Village of Arlington Heights
Plat and Subdivision Committee
Community Room, 3rd Floor
Arlington Heights Village Hall
33 S. Arlington Heights Road
Arlington Heights, IL 60005
January 28, 2015
6:30 PM

Item: South Campus & New Connections Academy - 3333 N. Kennicott Ave. - T1489

STAFF DEVELOPMENT COMMITTEE REPORT

Item: Northwest Metalcraft - 413 S. Arlington Heights Rd. - T1493

**PROPOSED
ELEVATIONS**

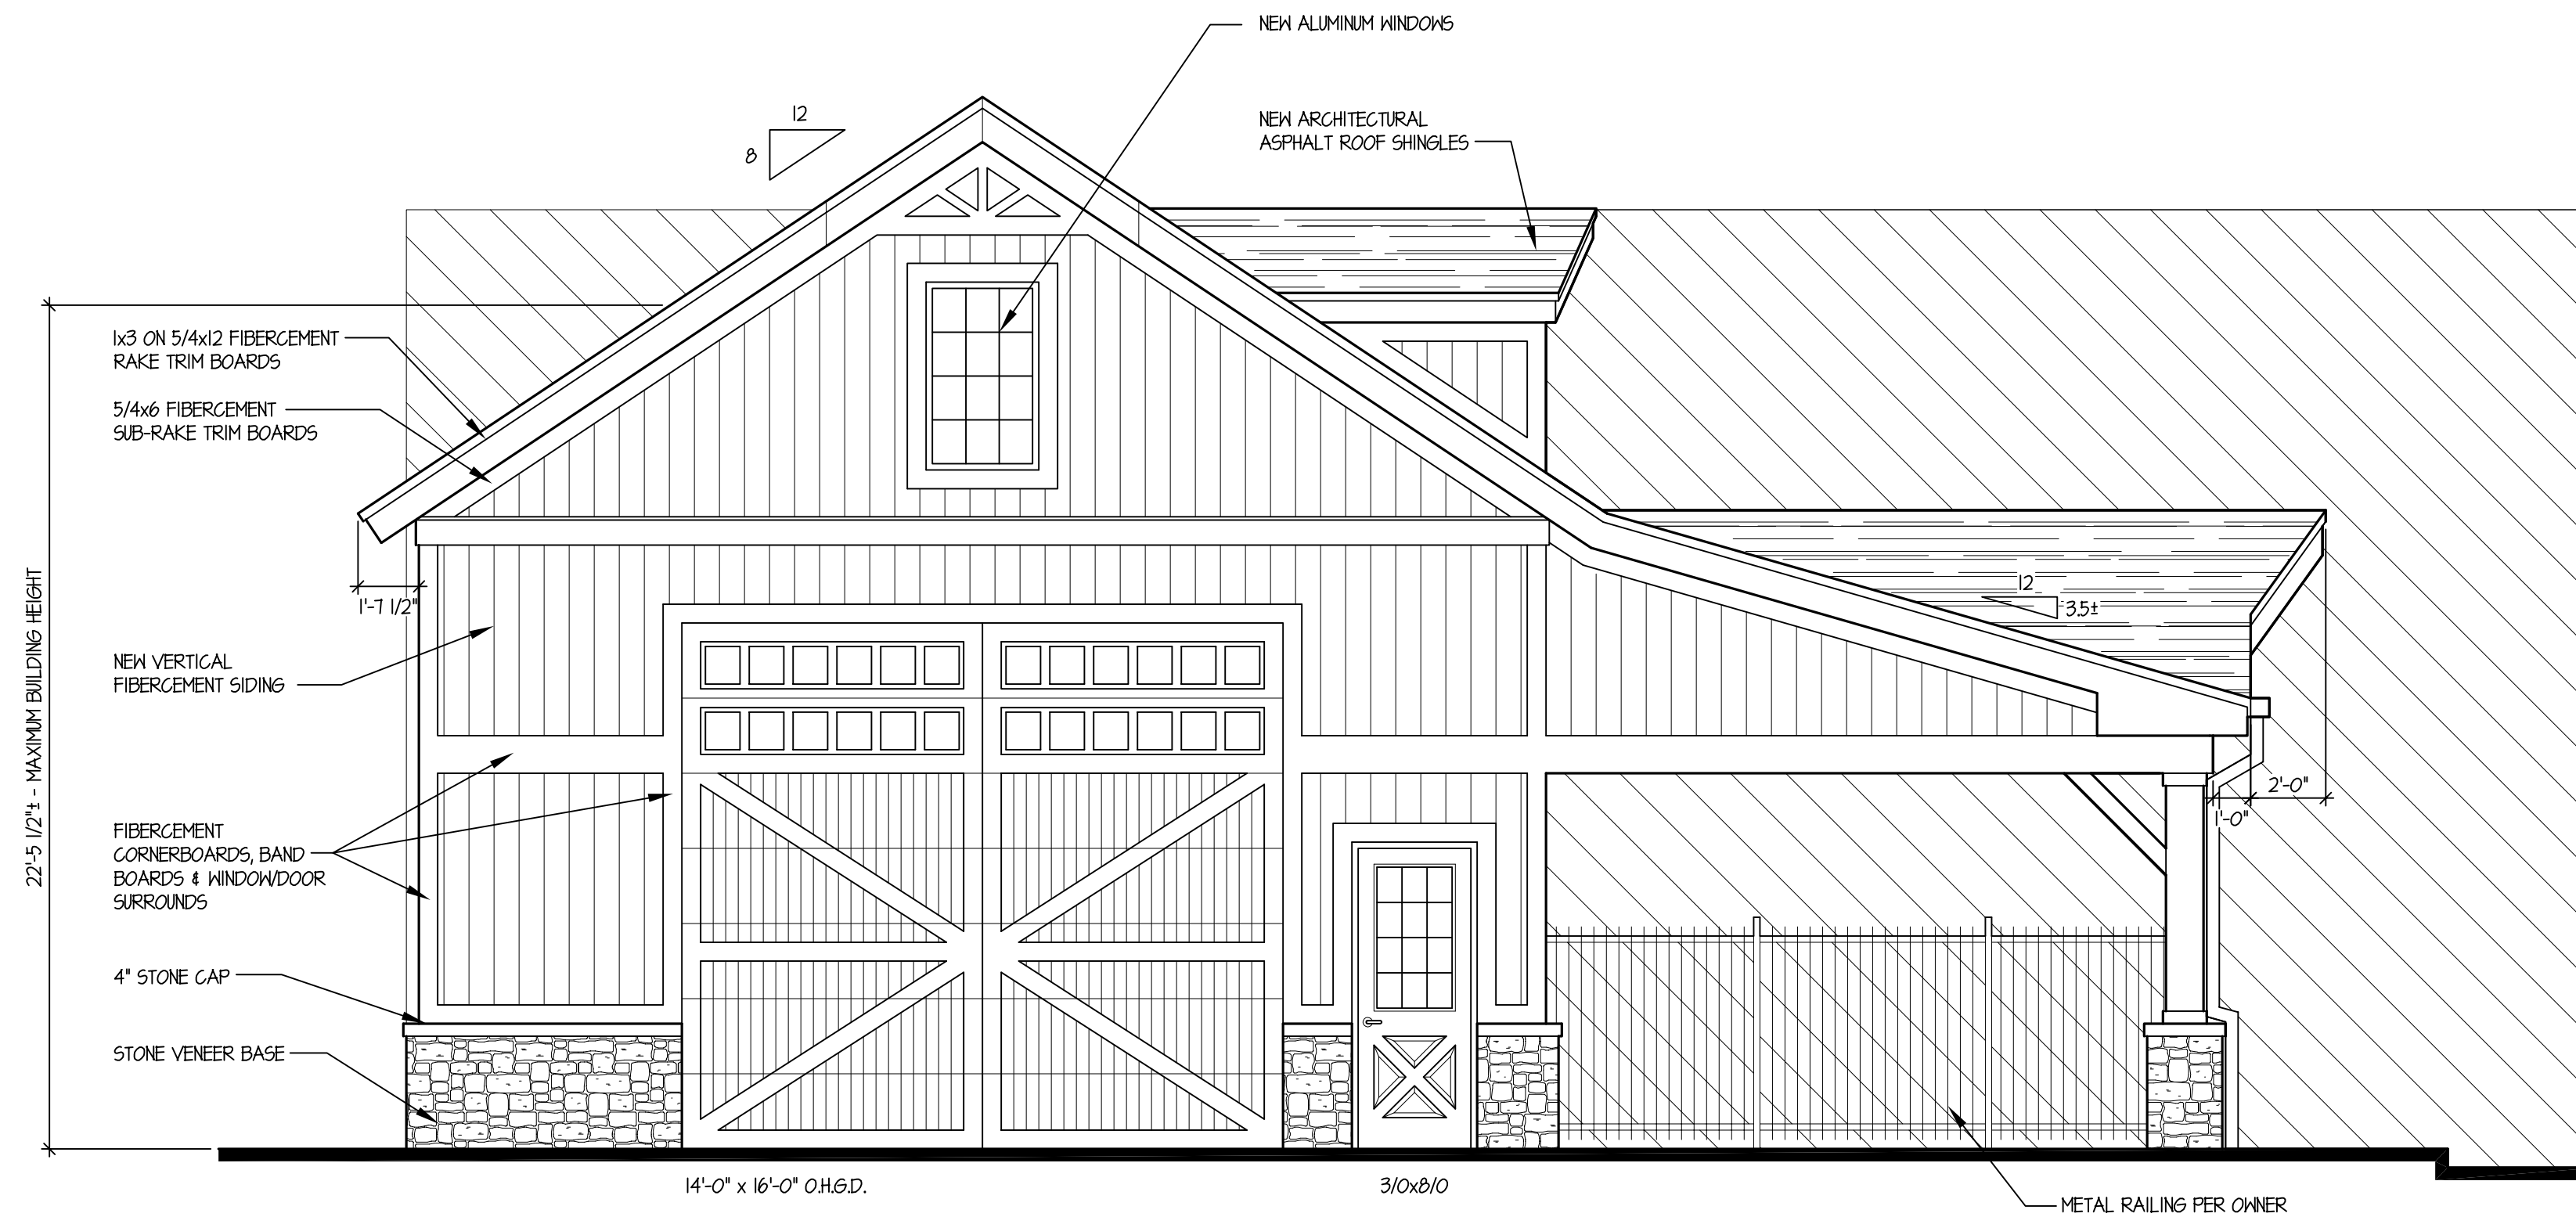
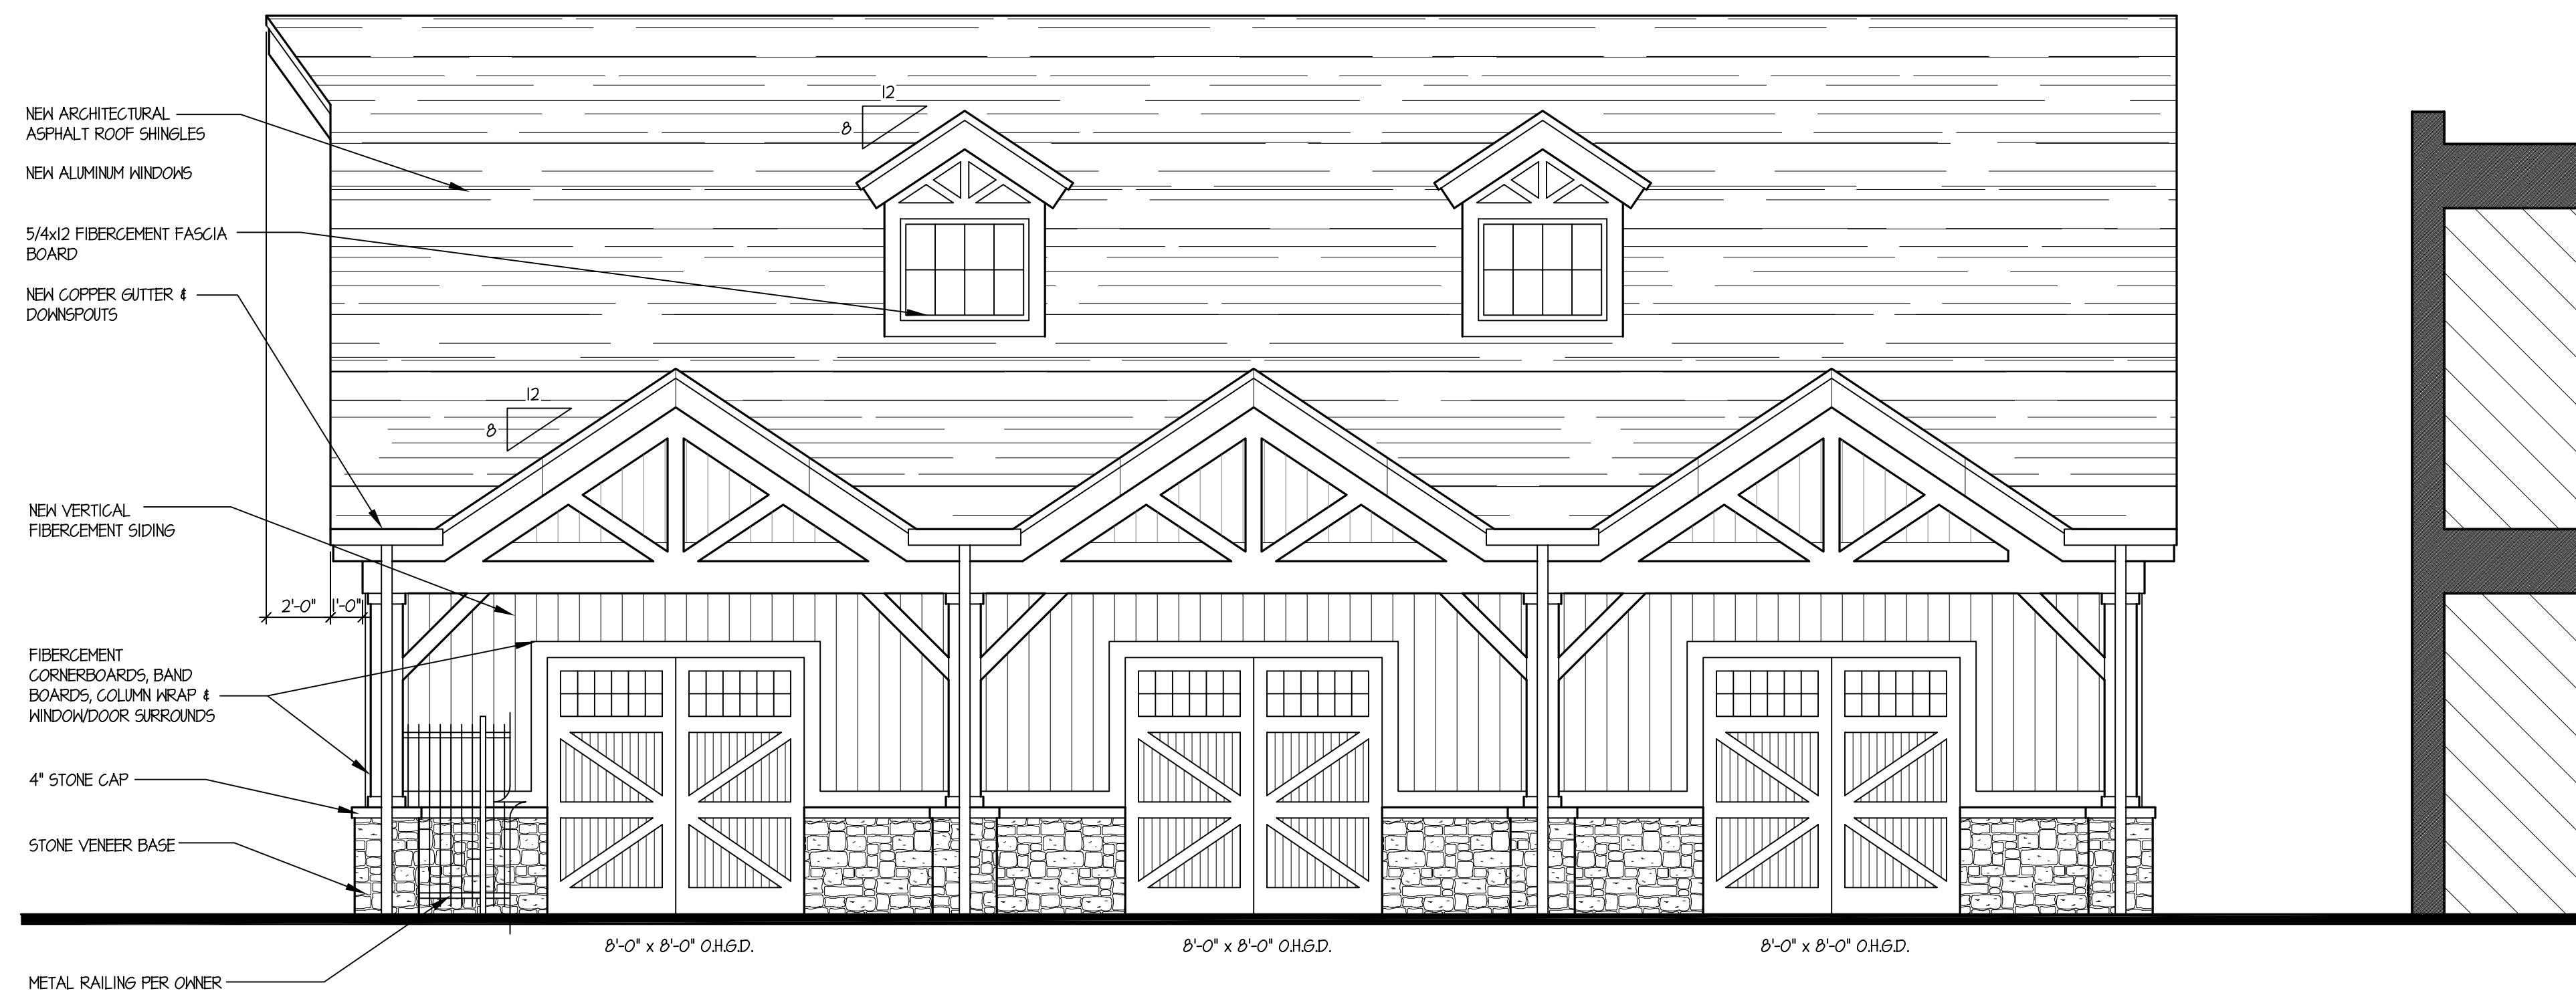
- **A variation from Chapter 28, Section 5.1-11.1, Conditions of Use, to allow outdoor sales in within a covered display area on the north side of the proposed storage barn;**

- A variation from Chapter 28, Section 6.5-2, from the requirement that an accessory structure including but not limited to a tool shed, storage building detached garage, tree house or gazebo, shall only be located in the rear yard to allow the proposed storage barn to be located in the side yard;
- A variation from Chapter 28, Section 6.5-6, from the requirement that no accessory structure or portion thereof shall exceed a height of 15 feet above grade to allow the storage barn to be 22 feet 5 inches;
- A variation from Chapter 28, Section 6.5-7, from the requirement that a playhouse, shed and gazebo cannot exceed 300 square feet in area to allow the storage barn to be 1,680 square feet.
